# Access Compliance Report

## Public Rights-of-Way

### (Curb Ramps)

Intersection ID: 12783	Main Street: 5TH_ST	Cross Street: ALEXANDER_RD	Location: E
ADA ID: 037F4ECAB6EC	Ramp Type: Perp	Initial Pass/Fail: Fail	Overall Compliance: No
		Severity Score: 12.5

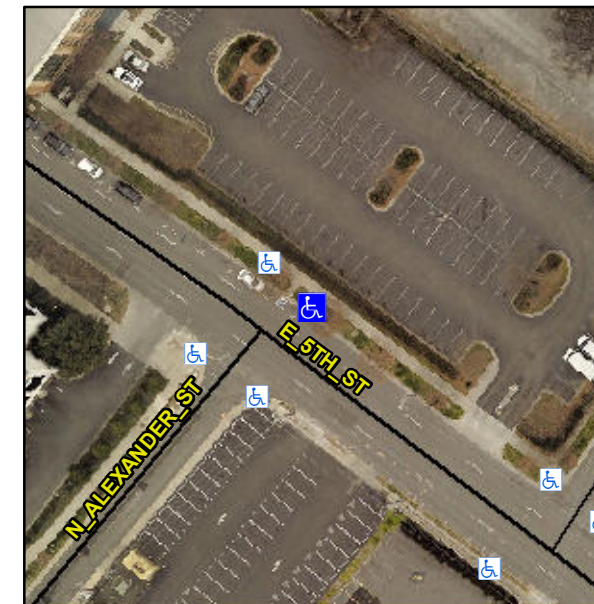
**Not Found, R304.2.2**

Compliance	Description	Data	Compliance	Description	Data
N/A	Ramp Length (in)	94.0	No	Ramp Slope (%)	9.8
Yes	Ramp Width (in)	59.0	Yes	Ramp XSlope (%)	0.6
N/A	Flare Type LT	N/A	N/A	Flare Type RT	N/A
N/A	Flare Slope LT (%)	N/A	N/A	Flare Slope RT (%)	N/A
N/A	Flare Traversable LT?	N/A	N/A	Flare Traversable RT?	N/A
N/A	Landing Length (in)	N/A	N/A	DWS Provided?	N/A
N/A	Landing Width (in)	N/A	N/A	DWS Contrast?	N/A
N/A	Landing Slope (%)	N/A	N/A	DWS Length (in)	N/A
N/A	Landing X Slope (%)	N/A	N/A	DWS Full Width?	N/A
N/A	Landing Curb? (Y/N)	N/A	N/A	DWS Offset (in)	N/A
N/A	Shared Landing?	N/A			
N/A	Gutter Ponding?	N/A	N/A	Gutter Slope (%)	N/A
N/A	Gutter Lip Ht (in)	N/A	N/A	Gutter X Slope (%)	N/A
N/A	Painted X Walk1?	No	N/A	Painted X Walk2?	N/A
	X Walk 1 Direction	To SW		X Walk 2 Direction	N/A
N/A	X Walk 1 Width (in)	N/A	N/A	X Walk 2 Width (in)	N/A
	X Walk 1 Slope (%)	3.9		X Walk 2 Slope (%)	N/A
	X Walk 1 X Slope (%)	2.1		X Walk 2 X Slope (%)	N/A

**Remove & Replace Entire Ramp.**
